**Re: "Study Session" for South Shores Church Project
Master Plan DEIR SCH#2009041129**

RESPONSE I-29-1

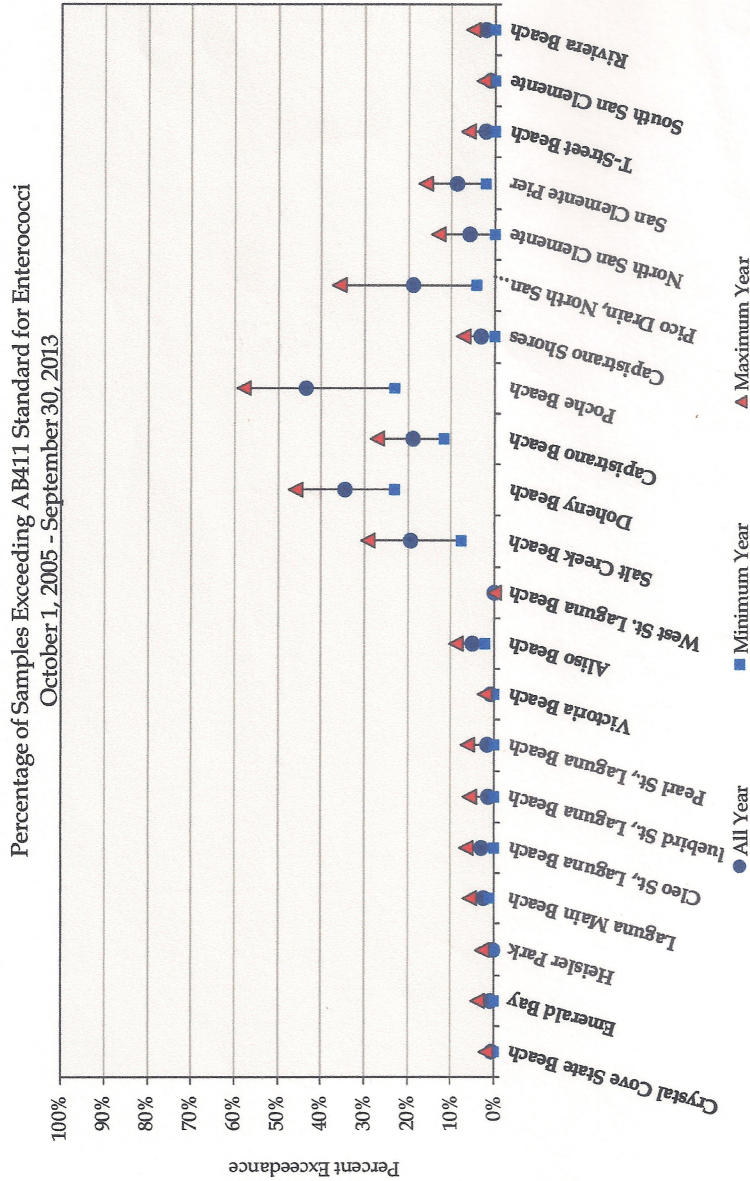
To avoid risking further impairment, the APPLICANT must integrate an AWT BMP into the cistern filtration inline system. Installed after the CDS unit reduces coarse

sediment and debris, plus performs minor hydrocarbon residue reductions. This will necessitate a stand alone (separate) NPDES Permit as approved by the SDRWQCB Region 9, Cal/EPA.

Encl: Left Turn Out Median Shelter Plan

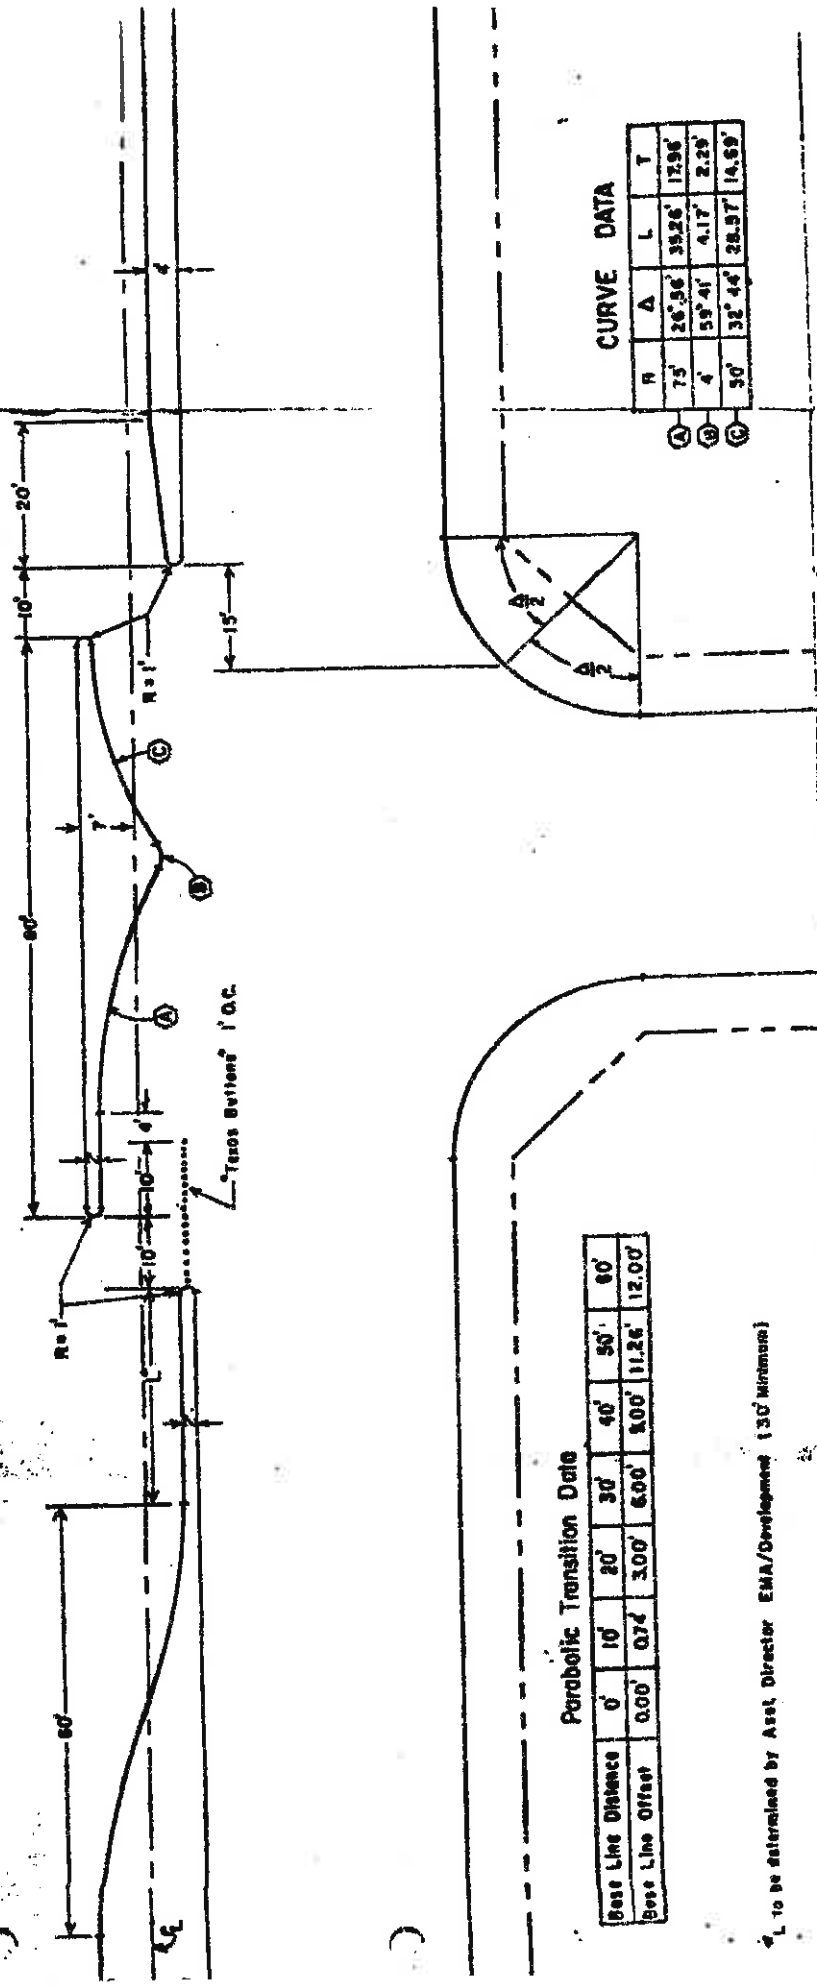
I-35-1

Encl: Left Turn Out Median Shelter Plan

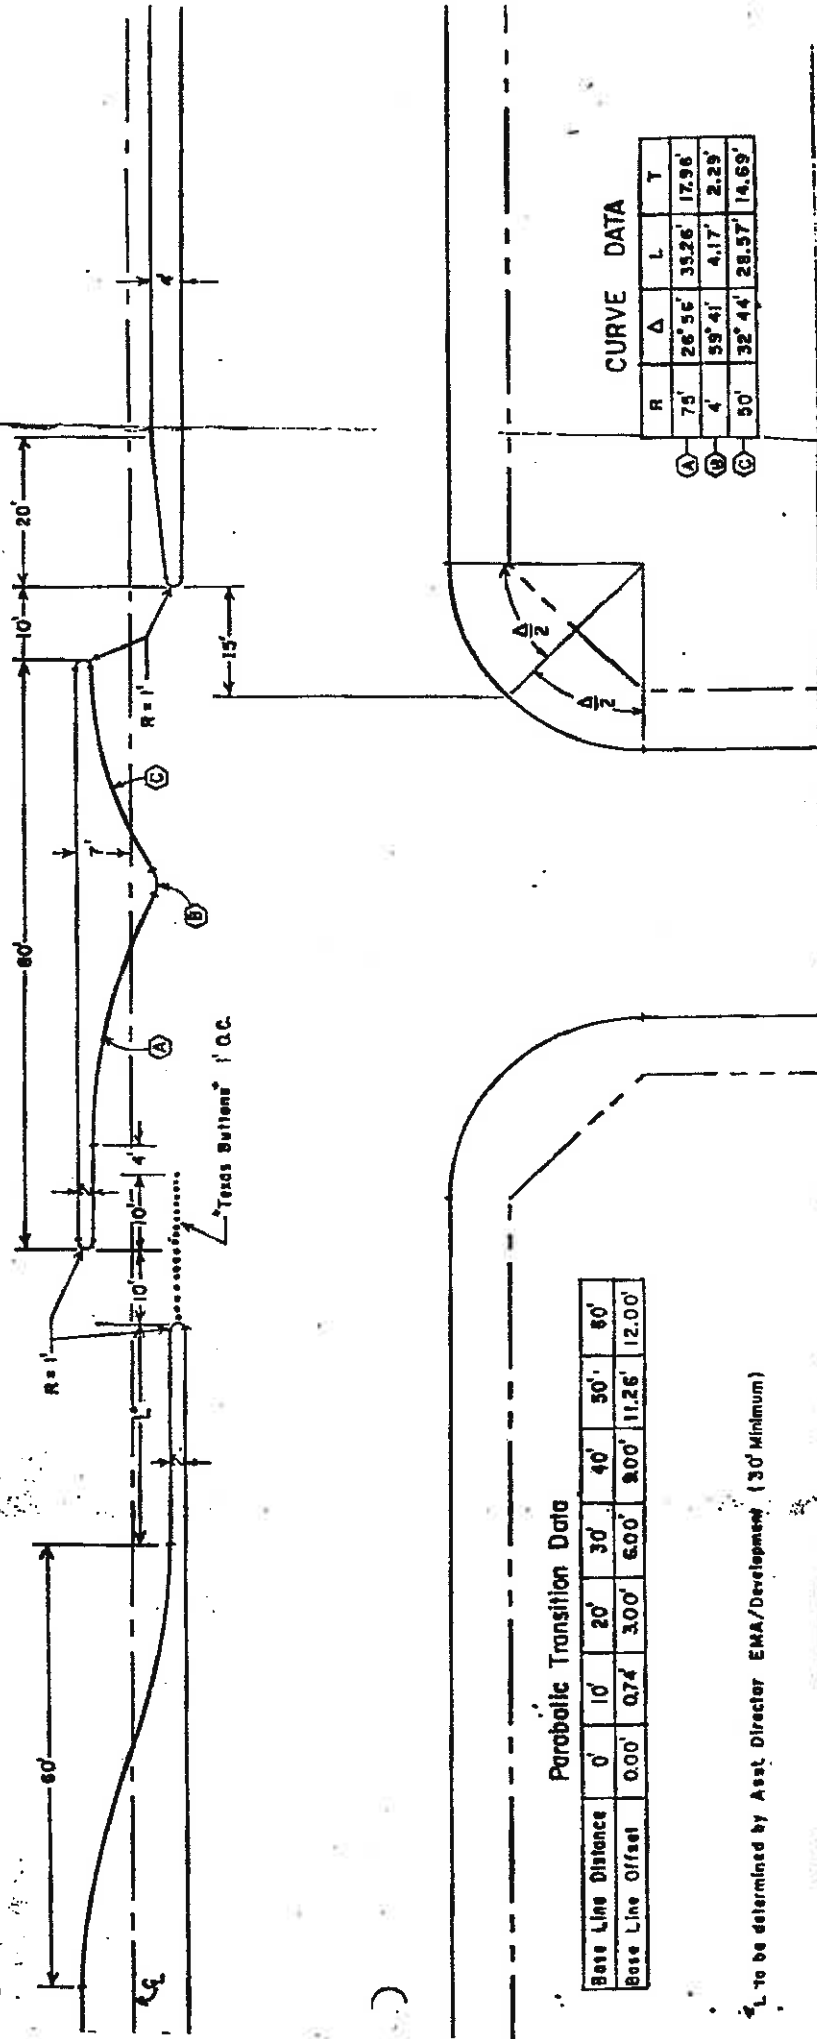
I-42-1
